**CITY OF BLOOMINGTON  
PLAN COMMISSION  
April 13, 2015 @ 5:30 p.m.**

**BLOOMINGTON PLAN COMMISSION**  
**STAFF REPORT – 2<sup>nd</sup> Hearing**  
**Location: 2894 E. 3<sup>rd</sup> Street**

**CASE #: PUD-05-15**  
**DATE: April 13, 2015**

**Date:** April 13, 2015  
**To:** Bloomington Plan Commission  
**From:** Bloomington Environmental Commission  
**Through:** Linda Thompson, Senior Environmental Planner  
**Subject:** PUD-5-15 Simon Property Group, College Mall, second hearing  
2894 E. 3<sup>rd</sup> Street

Project Number 2013.01249  
**MINIMUM CODE  
COMPLIANCE  
PLANTING PLAN**

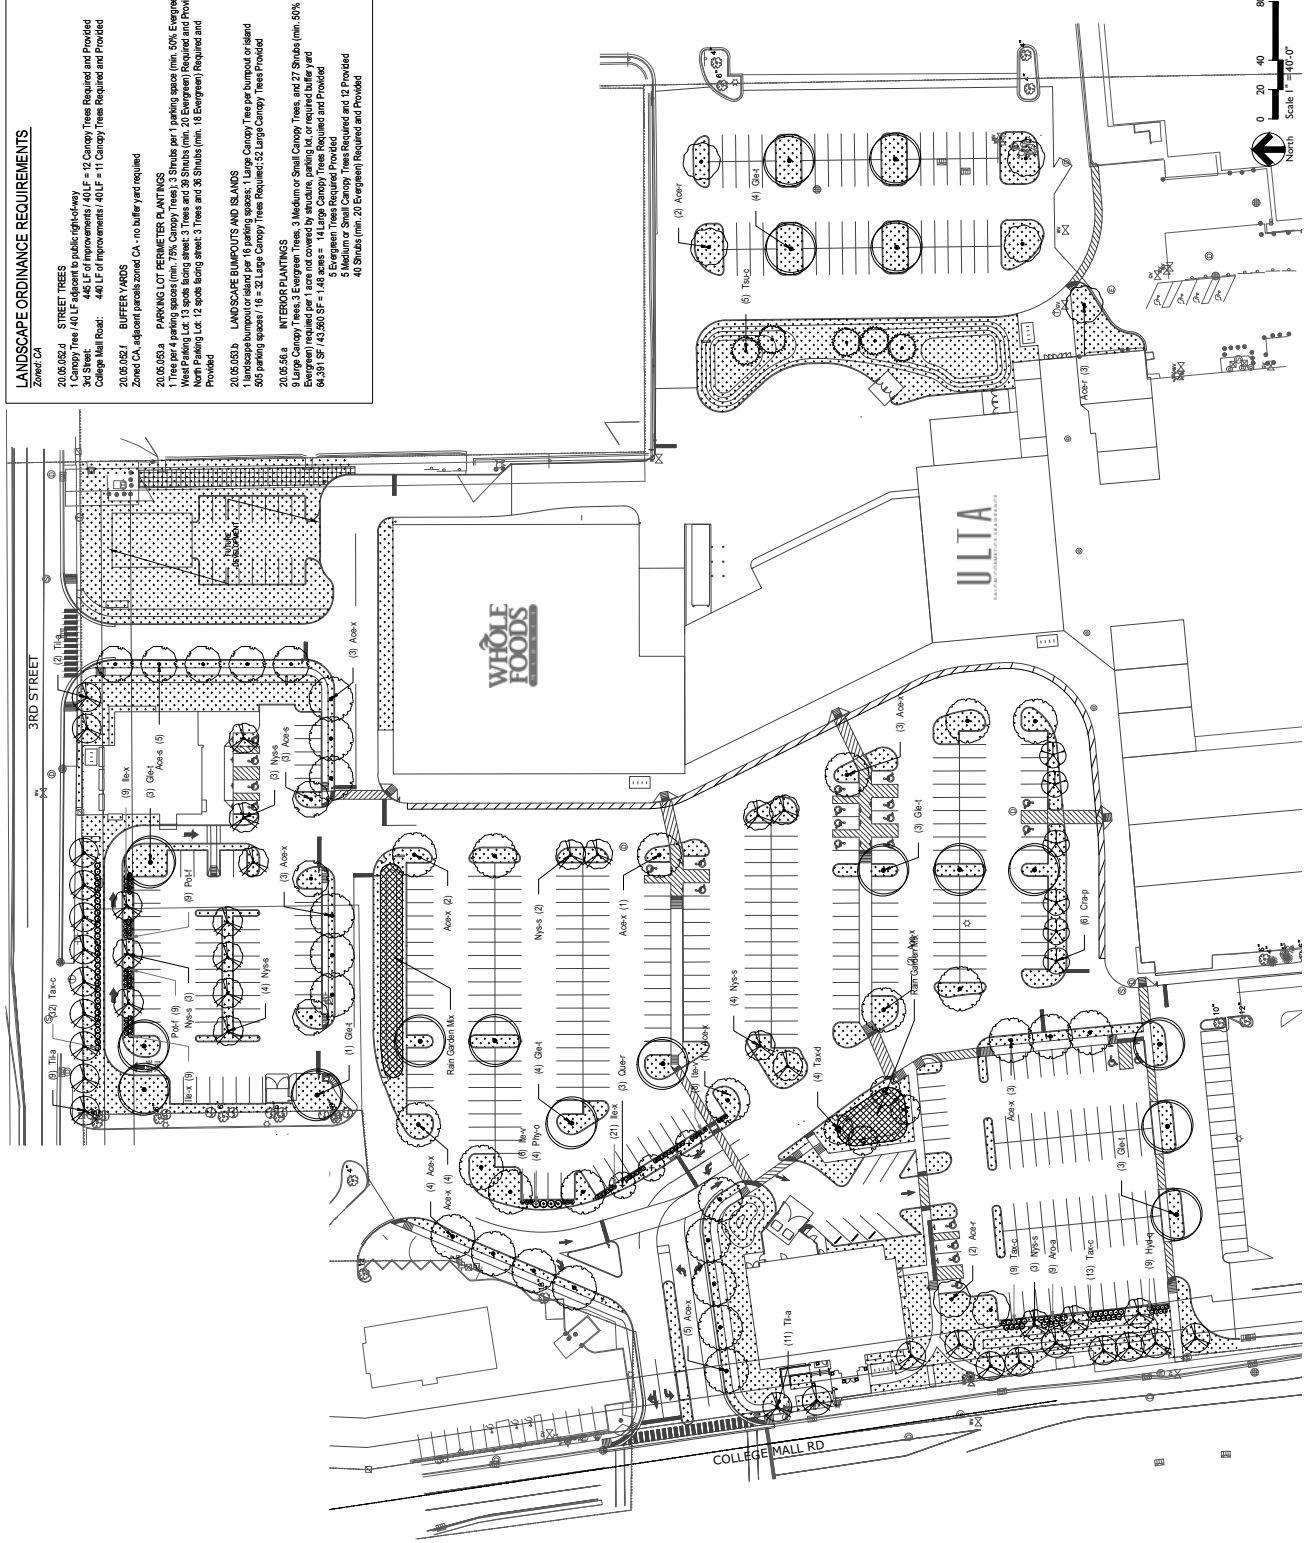
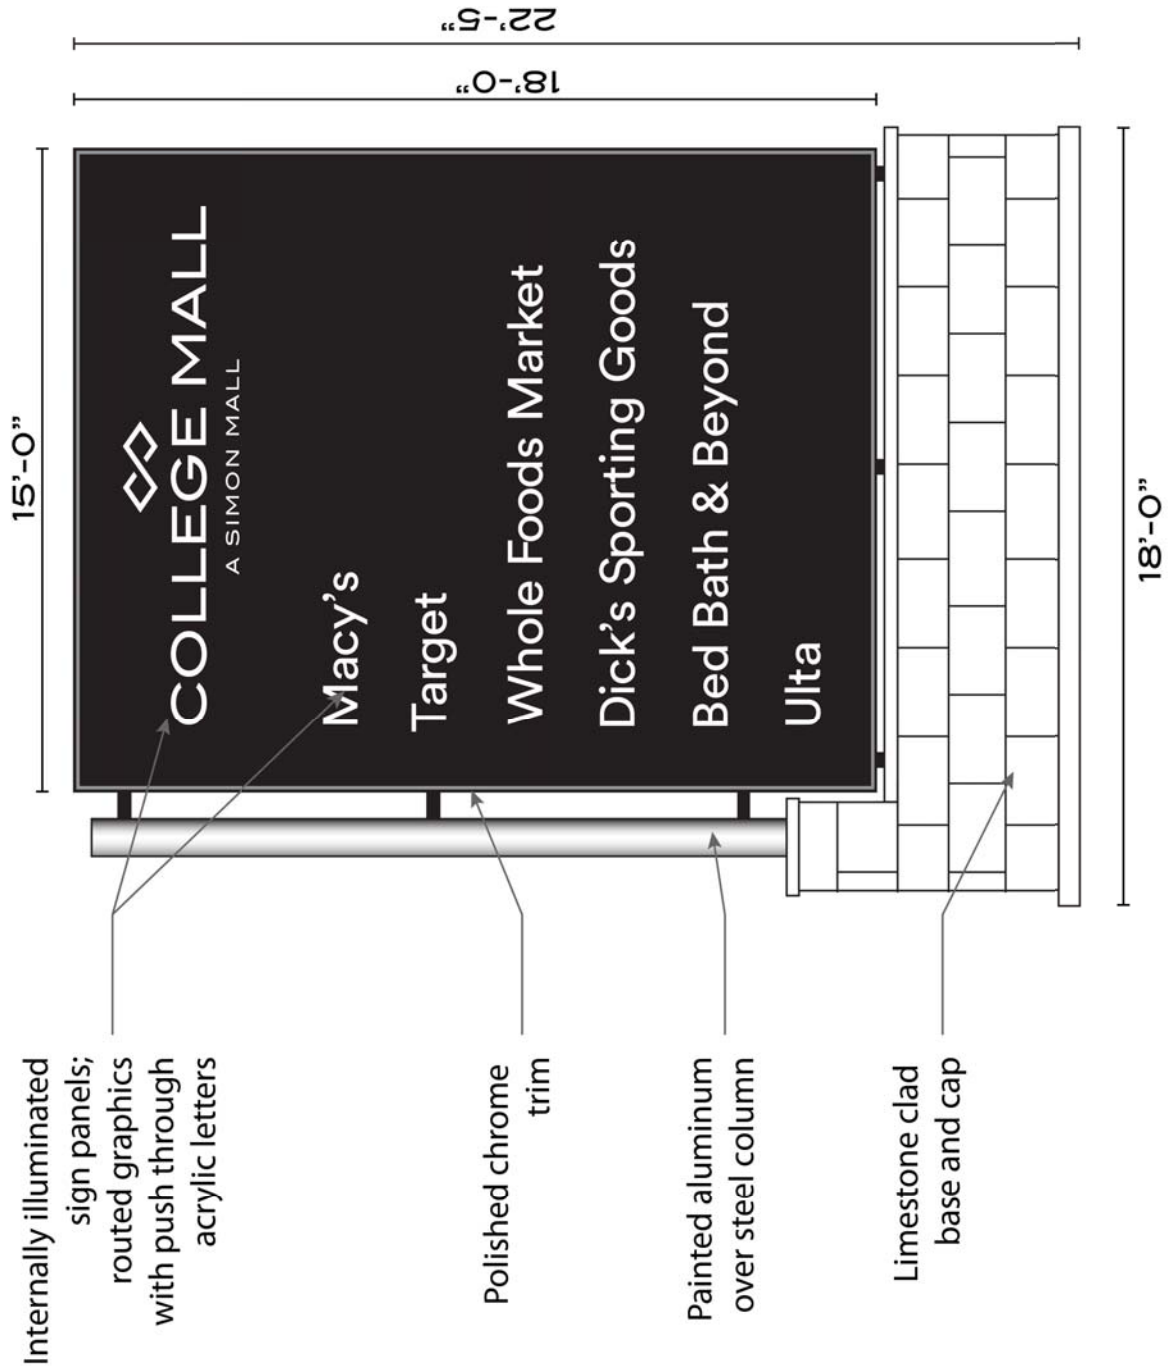
Although the site plan was revised, the Landscape Plan submitted still needs some revisions. The EC recommends that the Petitioner continue to work with the Planning & Transportation Department to create a plan that complies with the regulations, at the least. The EC promotes using native plant species in the landscaping. Native plants exemplify Indiana's natural heritage and benefit native birds and insects, particularly pollinators. Native plants provide food and habitat for birds, butterflies and other beneficial insects, promoting biodiversity in the city. Furthermore, native plants do not require chemical fertilizers or pesticides and are water efficient once established.

The EC also recommends that the Petitioner remove and replace the ash trees that are not within the scope of this redevelopment project, but are elsewhere on the Simon, College Mall property. Ash trees are being decimated by the Emerald Ash Borer, and unless the trees are chemically treated, they will likely not survive. The city's Urban Forester, the Tree Commission, and the EC all recommend removing existing ash trees now rather than waiting for them to slowly die, enabling new trees to be established. When choosing replacement trees, the EC recommends employing an arborist to test the soil and recommend appropriate trees to use in specific

**Staff response:** Staff will continue to work with the petitioner on improving the landscape plan and incorporating native plants where possible. Staff will also work to identify any Ash trees on the property and have those replaced with new species.

PUD-05-15  
BJ's Architecture

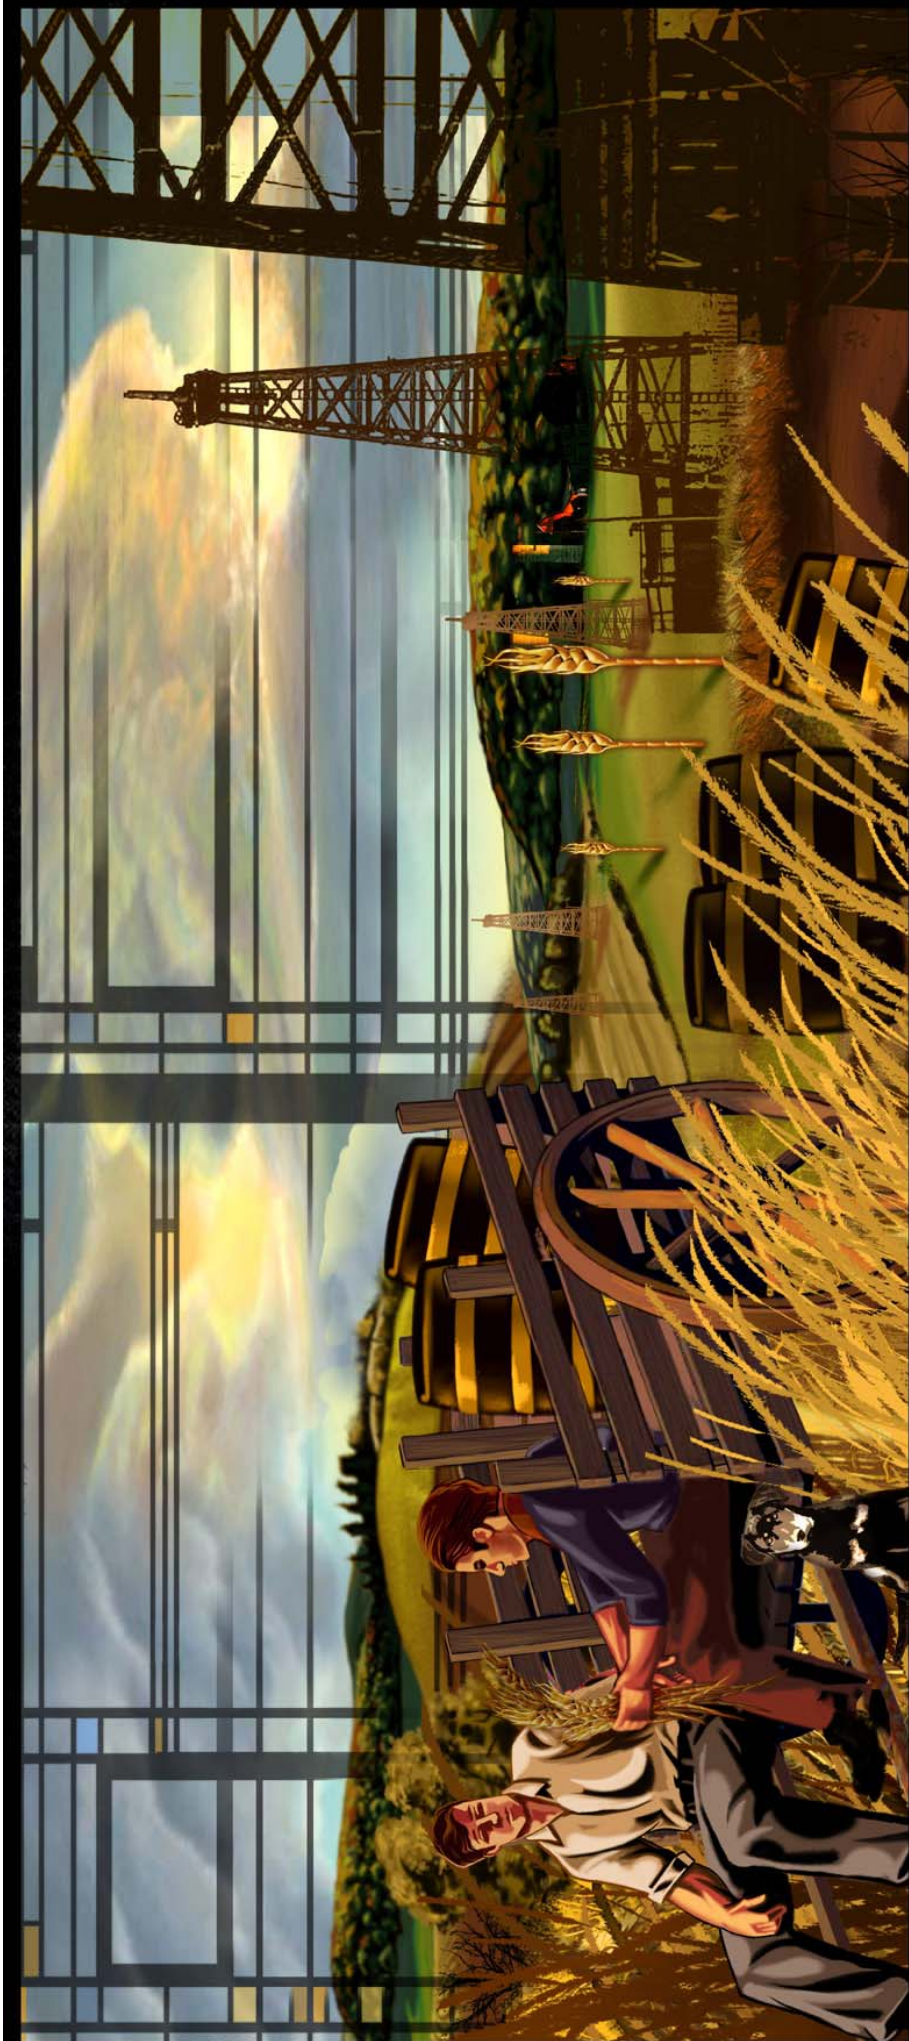
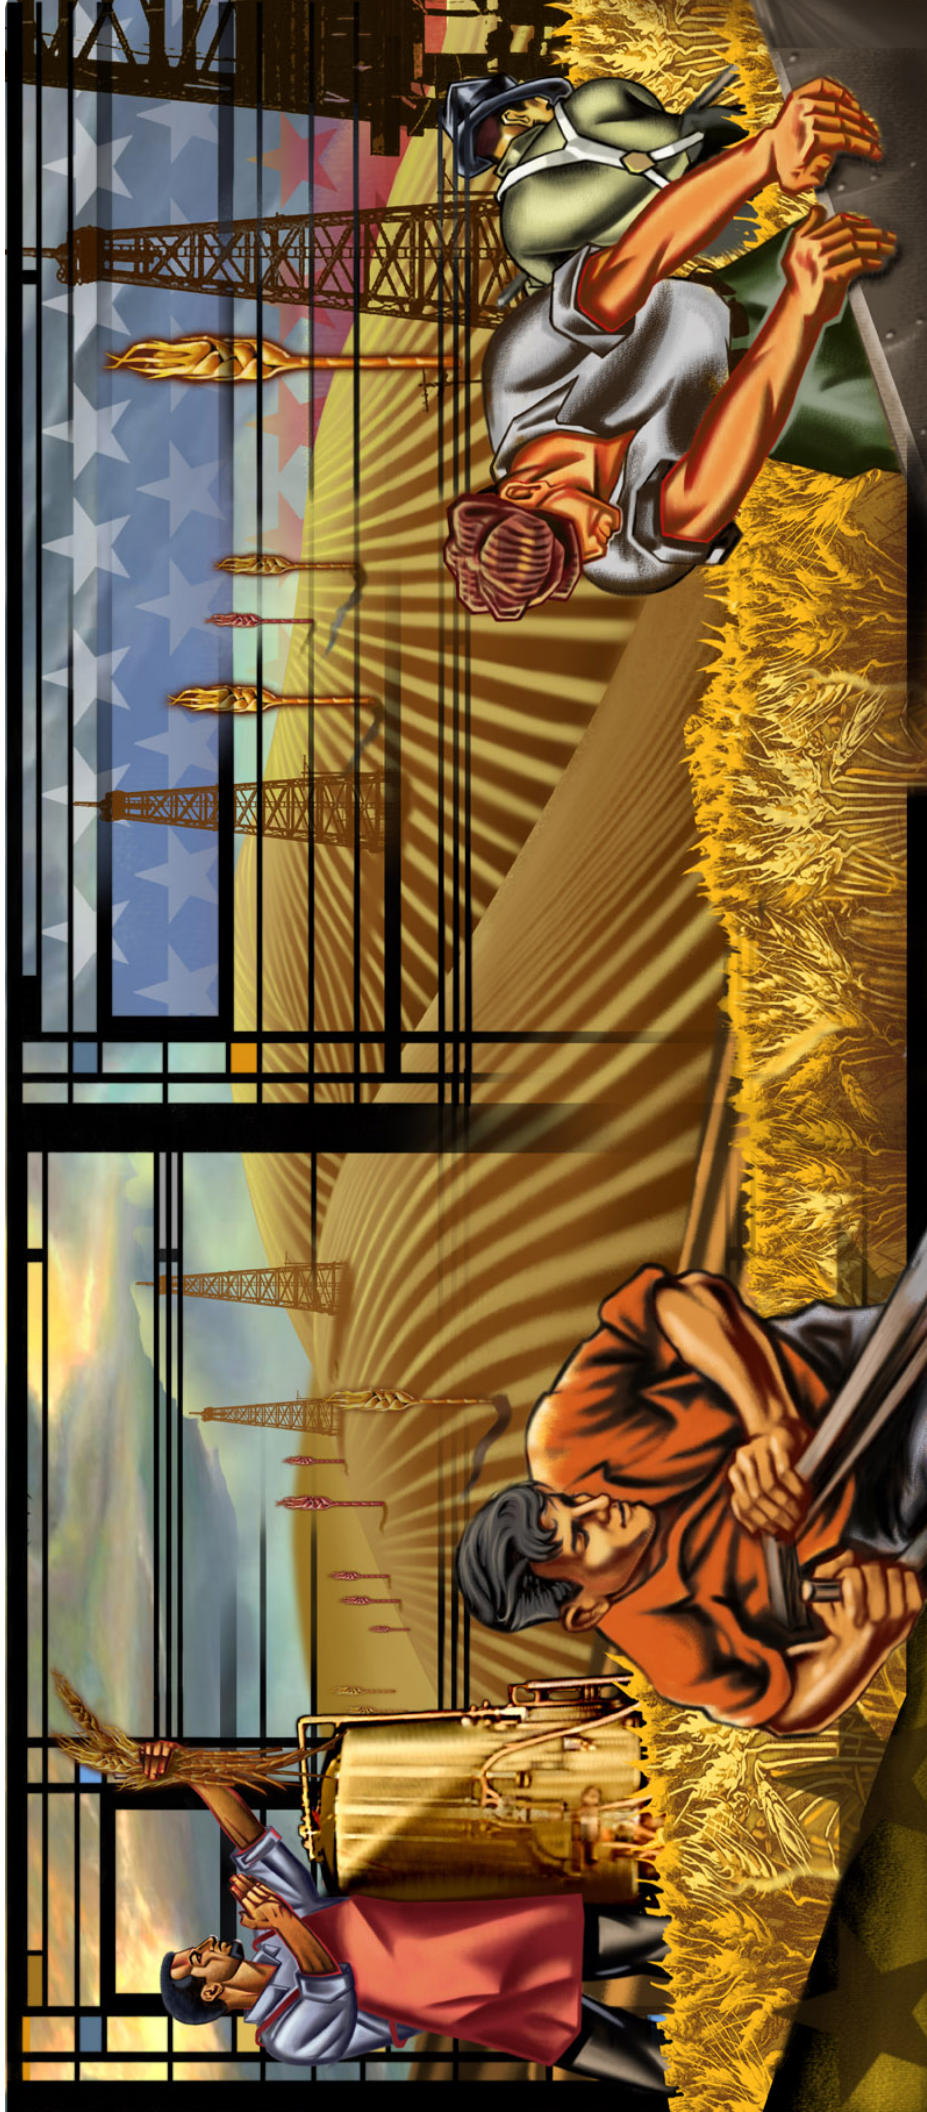
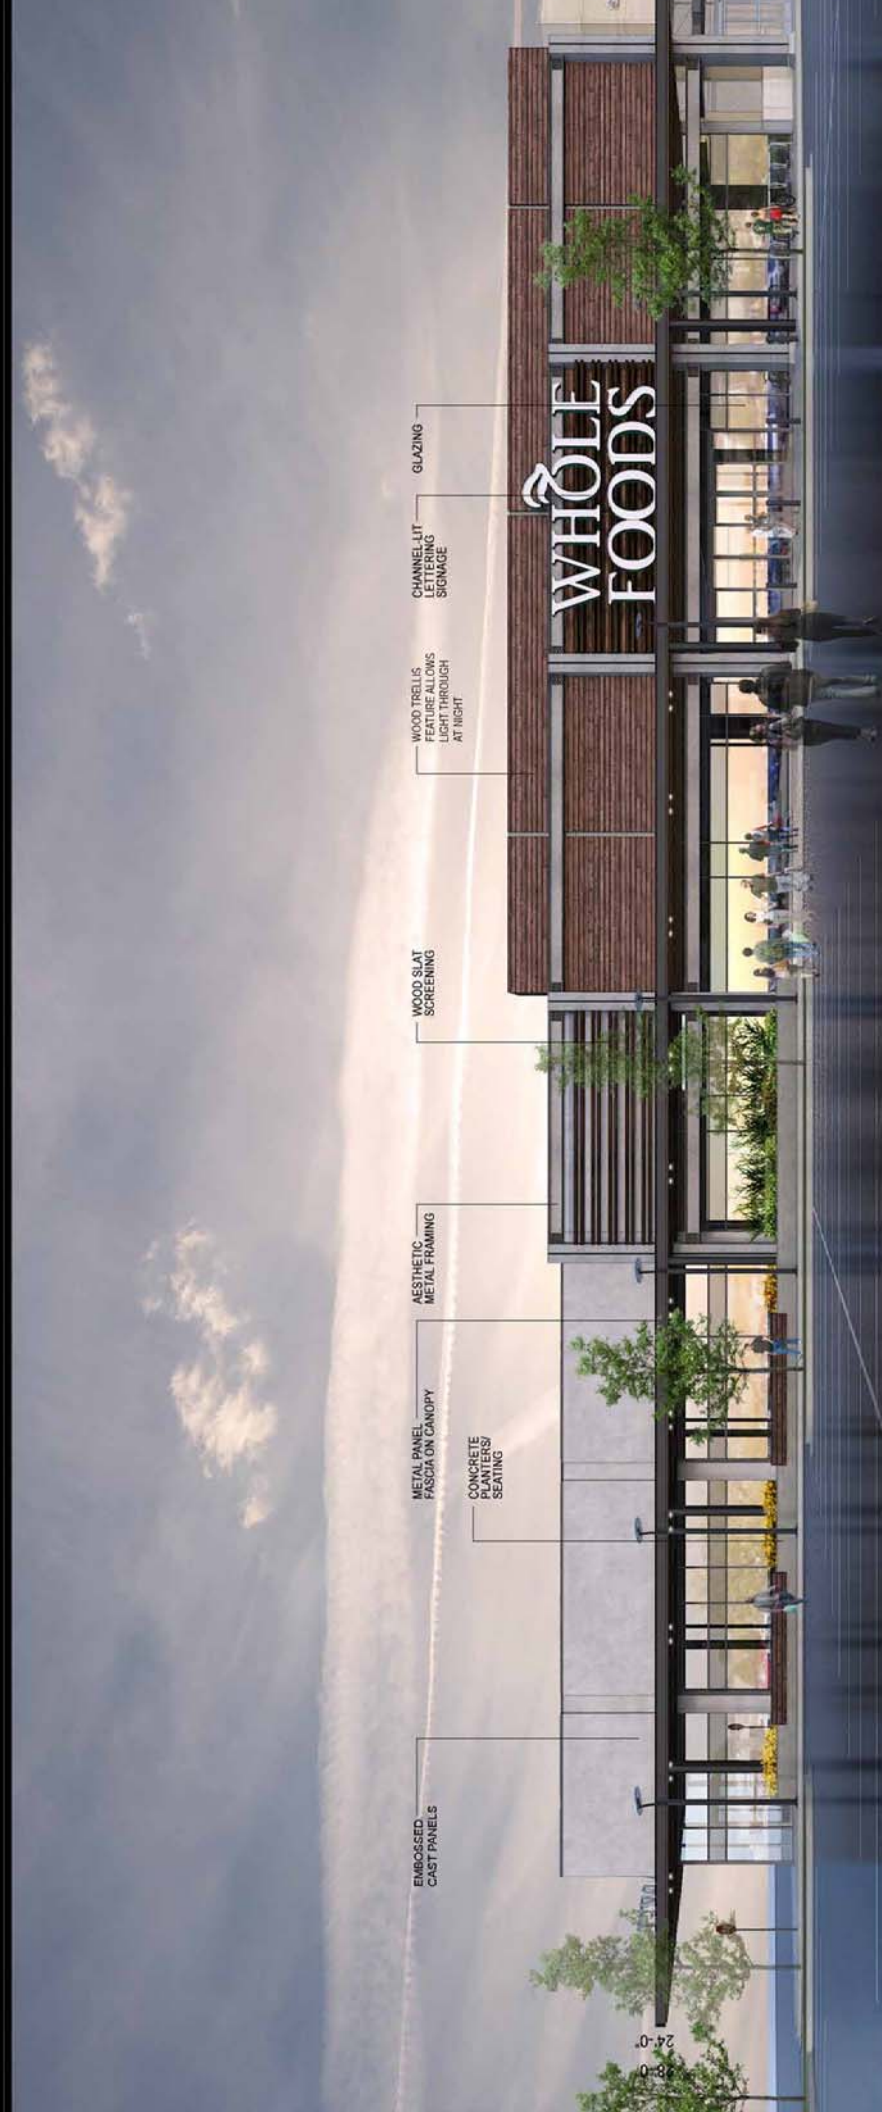
**BJ's Restaurant:** At the first hearing staff requested comments for the proposed murals that are shown. The Plan Commission indicated that if the murals are proprietary and found at other BJ's restaurants, then they would be considered signs. If murals are installed that depict local scenes, then they would not be considered signs. Staff has proposed a condition of approval that if the signs are proprietary, then they would be considered signs. Elevations have been submitted for the 7,500 sq. ft. BJ's Restaurant and Brewery which show elements of brick along the building corners and entrance, with a smooth faced concrete block around the lower portions of the façade. The rest of the façade is EIFS. The petitioner has used the architectural guidelines of the UDO to create elements of the building façade that are recessed by the use of the extended corners and projecting entrance canopy, as well as changes in overall building height along the length of the building.

Staff had also requested guidance from the Plan Commission for the proposed murals shown on the exterior of the BJ's restaurant. The Plan Commission indicated that if the murals are proprietary and found at other BJ's restaurants they would be considered signs. Staff has proposed a condition of approval that if the signs are proprietary then they would be considered signs, but if murals are installed that depict local scenes they would not be considered signs.
